7-ELEVEN
CONVENIENCE STORE WITH FUEL
7430 204TH STREET NORTHEAST
ARLINGTON, WA 98223
CITY OF ARLINGTON

7-ELEVEN
PRAIRIE CREEK VILLAGE
ARLINGTON, WA
COVER SHEET

7-ELEVEN
PRAIRIE CREEK VILLAGE
ARLINGTON, WA
SITE PLAN AS-BUILT

7-ELEVEN
PRAIRIE CREEK VILLAGE
ARLINGTON, WA
GRADING AND DRAINAGE AS-BUILT
C-20

7-ELEVEN
 PRAIRIE CREEK VILLAGE
 ARLINGTON, WA
 GRADING AND DRAINAGE AS-BUILT
 C-20

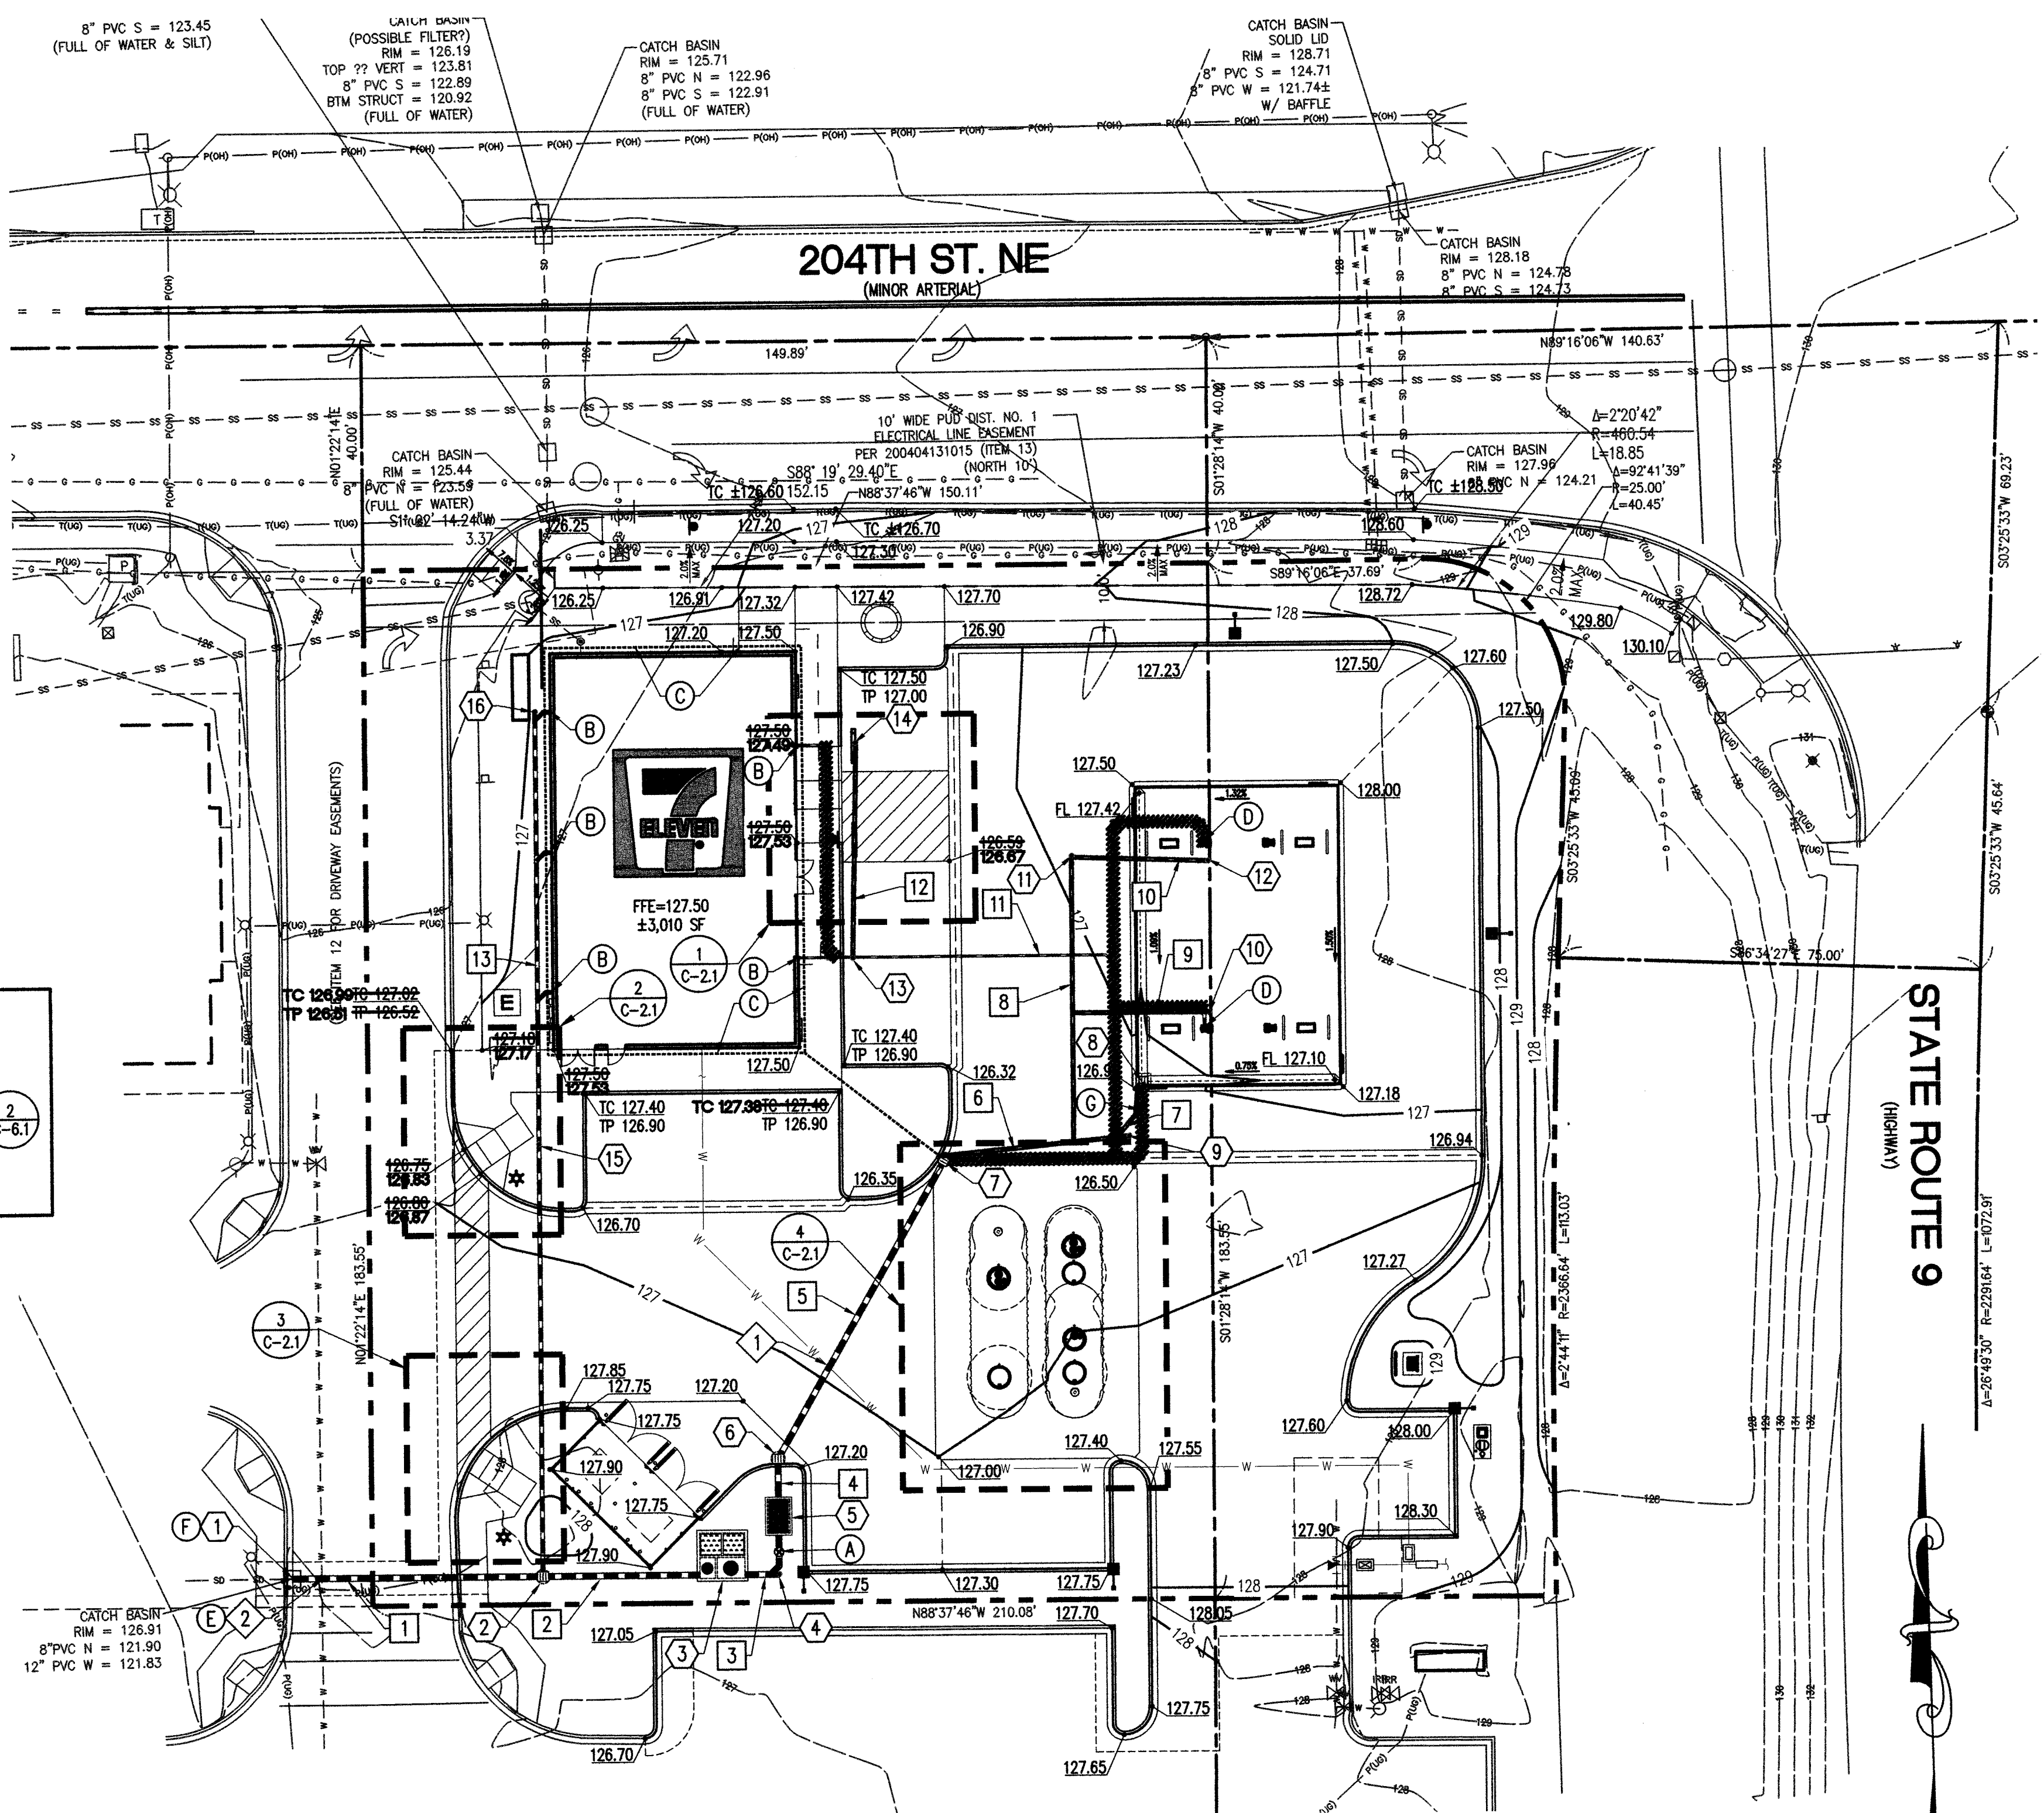
- (F) CORE DRILL INTO EXISTING CATCH BASIN TO INSTALL NEW STORM PIPE. GROUT AROUND PENETRATION USING A NON-SHRINKING MORTAR TO OBTAIN A WATERTIGHT CONNECTION. CONTRACTOR SHALL ENSURE THE STRUCTURAL INTEGRITY OF THE EXISTING MANHOLE IS NOT COMPROMISED AS A RESULT OF THE ADDED PIPE CONNECTION. **NEW 12" PIPE NOT INSTALLED. EXISTING 8" PIPE USED.**

RIM=126.91
IE(EX 8"N)=±121.90
IE(EX 12"W)=±121.83
IE(12"E)=121.87
IE(EX 8"E)=±121.83 | 2 PVC CATCH BASIN, SL
RIM=126.25 127.44
IE(12"E,W)=±122.05 122.09
IE(8"N)=±122.05 121.99
IE(8"W)=122.03 | 3 MODULAR WETLAND
RIM=126.51
IE(12"W)=±122.10 122.46
IE(8"N)=±122.05 121.99
IE(12"E)= ±123.69 123.90 | 4 SDCO
RIM=ATG
IE=123.72 | 5 O/W SEPARATOR
RIM=126.10 128.15
IE(12"N,S)=±123.76 123.99
SEE DETAIL 1, SHEET C-6.2 |

RIM=127.15 127.13
IE(12"N,S)=123.80
IE(12"NE)=124.01
IE(12" S)=123.99 | 7 PVC CATCH BASIN, GR
RIM=126.26 126.25
IE(12"S)=±124.10 124.15
IE(8"E)=±124.10 124.09
IE(8" W)=±124.10 124.43 | 8 TYPE 1 CB, PGR
RIM=126.86 126.76
IE(6"S)=±124.57 124.68
STRUCTURE MUST PROVIDE A MINIMUM 3" SUMP BELOW OUTLET PIPE INVERT FOR SPILL CONTROL. | 9 SDCO
RIM=ATG 126.65
IE=124.45 | 10 SDCO
RIM=ATG 127.08
IE=124.80 |

RIM=ATG 127.05
IE=125.00 | 12 SDCO
RIM=ATG 127.34
IE=125.16 | 13 SDCO
RIM=ATG 126.82
IE=125.27 | 14 SDCO
RIM=ATG 126.90
IE=125.65 | 15 SDCO NOT INSTALLED
RIM=ATG
IE=123.26 |

L=44' 39"
S=0.50% | 2 12" CPEP
L=28' 32"
S=0.50% 1.16% | 3 12" CPEP
L=14' 11"
S=0.50% 0.80% | 4 12" CPEP
L=7' 6"
S=0.50% 0.0% | 5 12" CPEP
L=64' 62"
S=0.50% 0.21% |

L=35' 33"
S=1.00% 1.40% | 7 6" CPEP
L=13' 10"
S=1.00% 1.40% | 8 6" CPEP
L=66' 51"
S=1.00% | 9 6" CPEP
L=19' 24"
S=1.00% | 10 6" CPEP
L=19' 24"
S=1.00% |

L=56' 39"
S=1.00% | 12 4" CPEP
L=38"
S=1.00% | 13 8" CPEP
L=153"
S=1.50% | | |

7-ELEVEN
 PRAIRIE CREEK VILLAGE
 ARLINGTON, WA
 UTILITY PLAN AS-BUILT

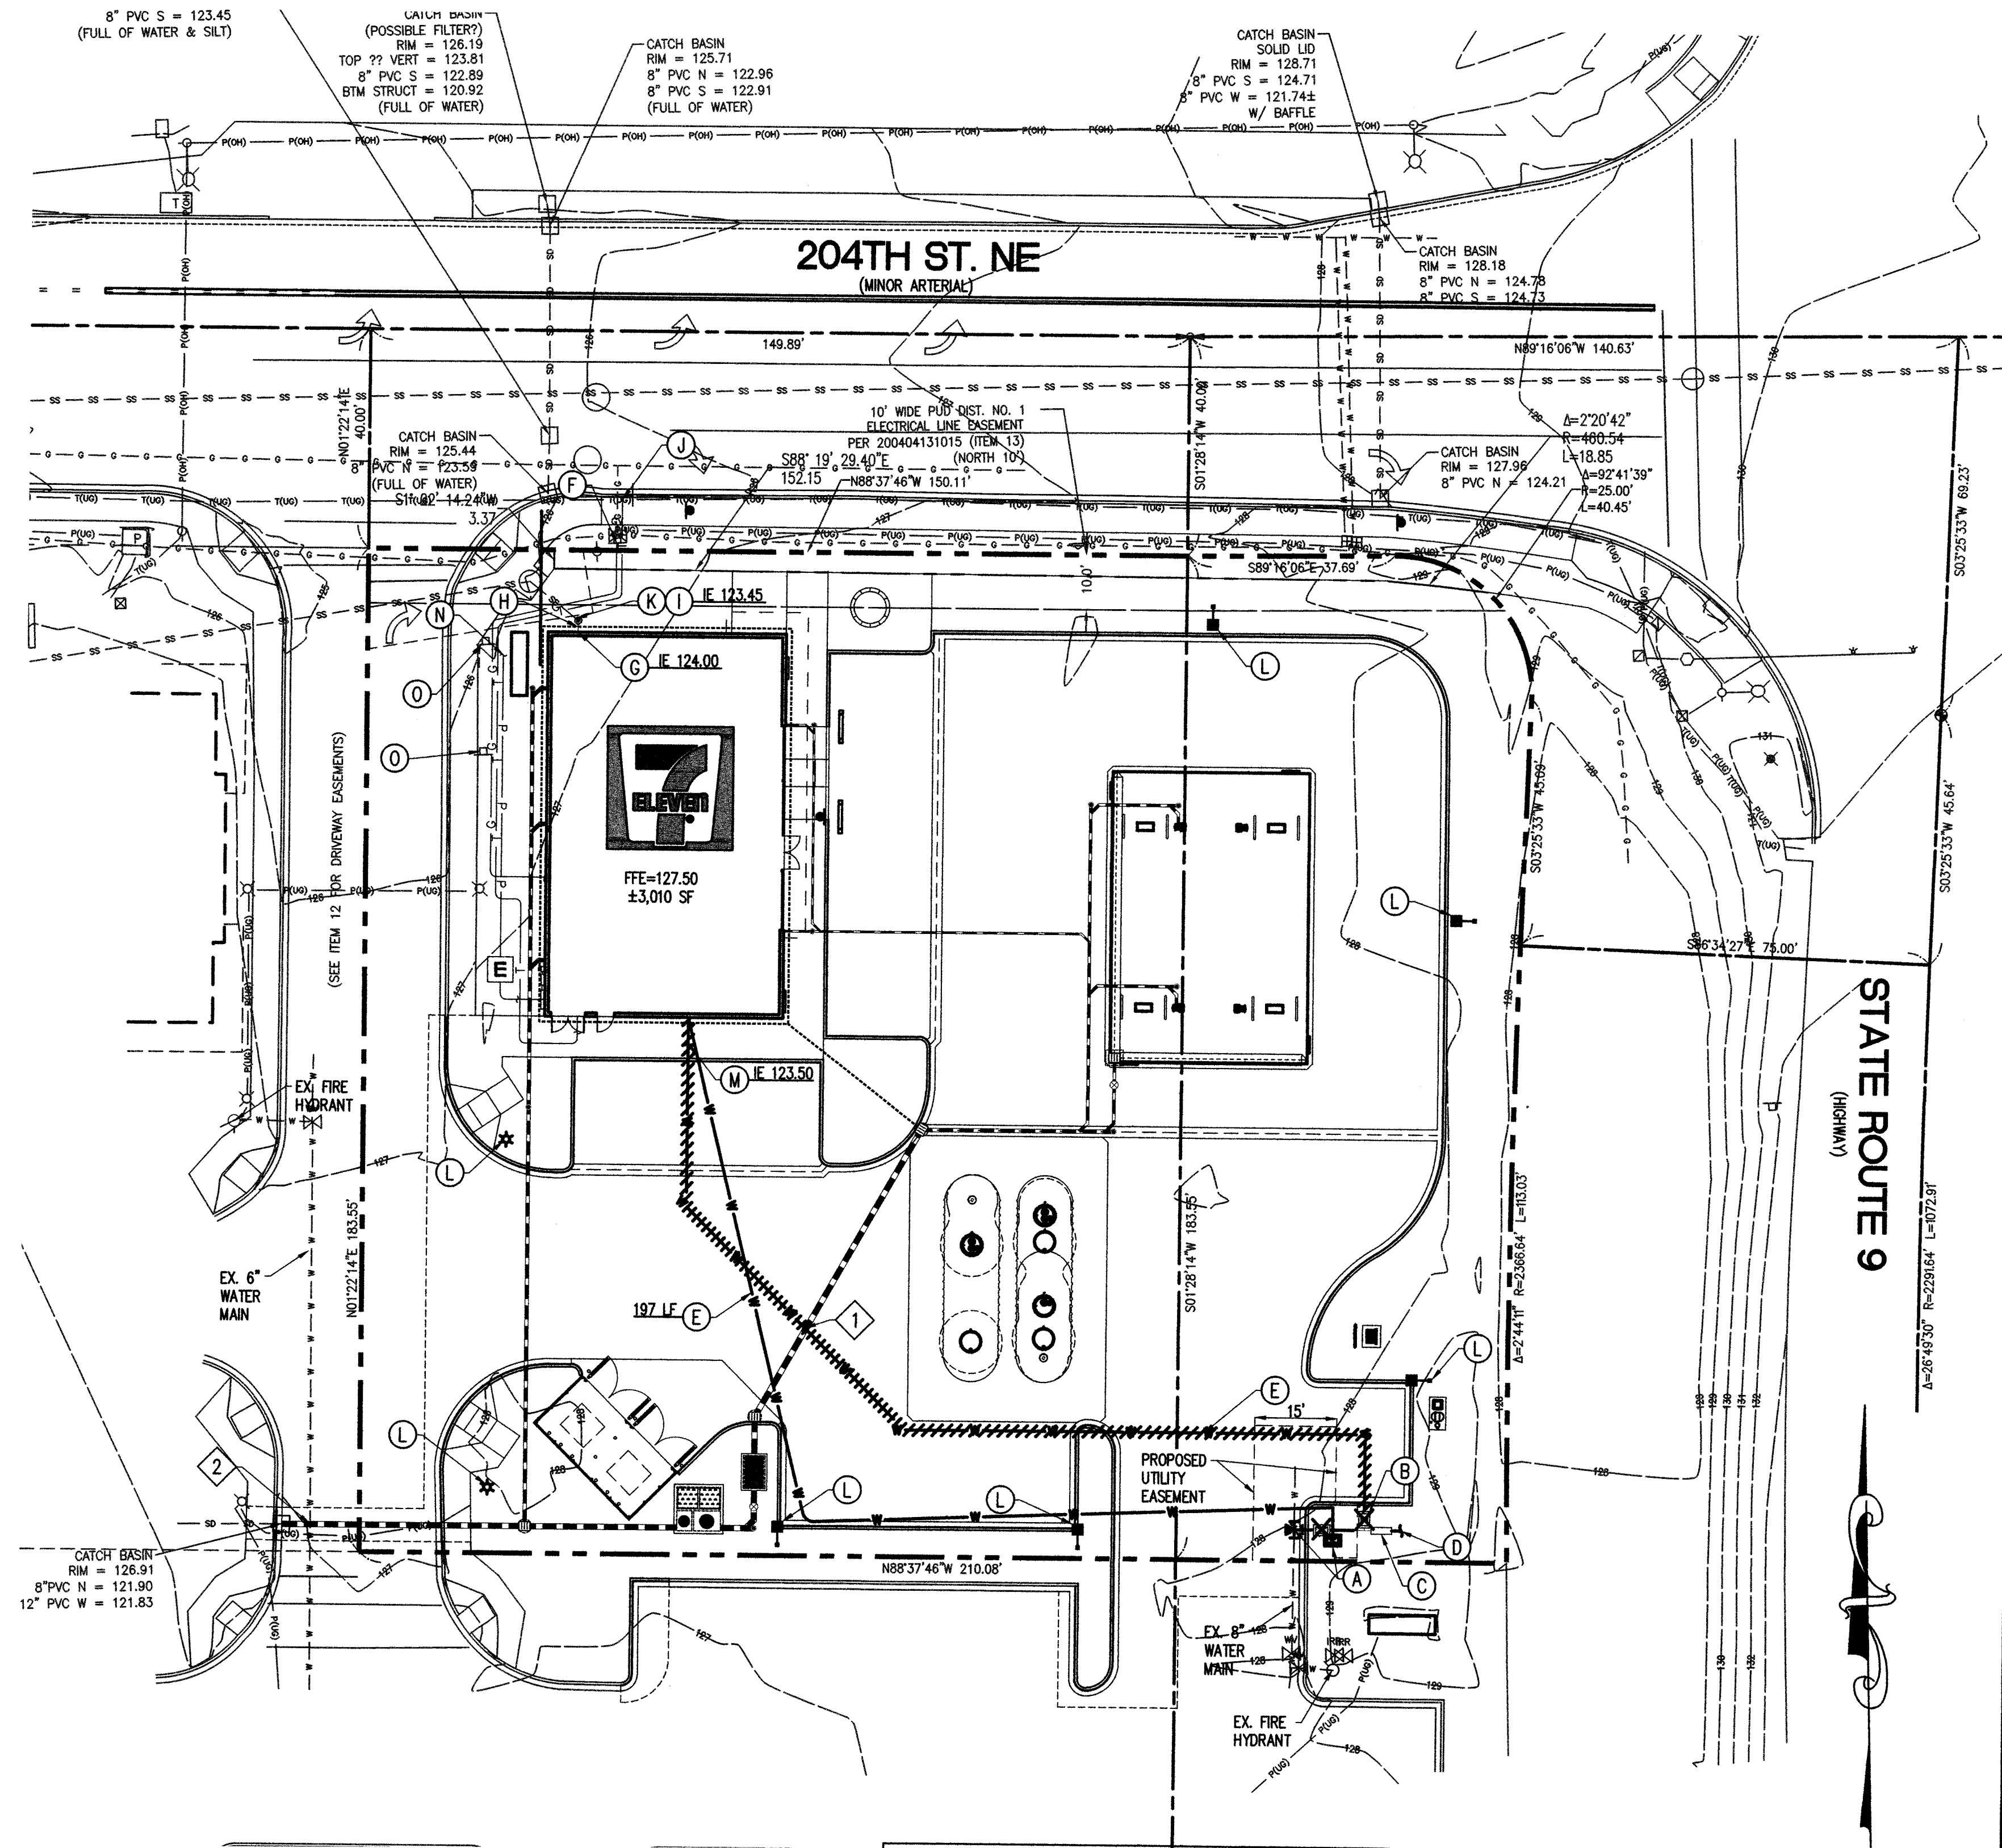
- (1.2 / C-7.0) (A) INSTALL 2" COMMERCIAL DOMESTIC WATER SERVICE WITH 1" METER, PER COA STANDARD DETAIL W-050.
- (4 / C-7.0) (B) INSTALL 1" RPBA, PER COA STANDARD DETAIL W-130. **INSTALLED IN BUILDING**
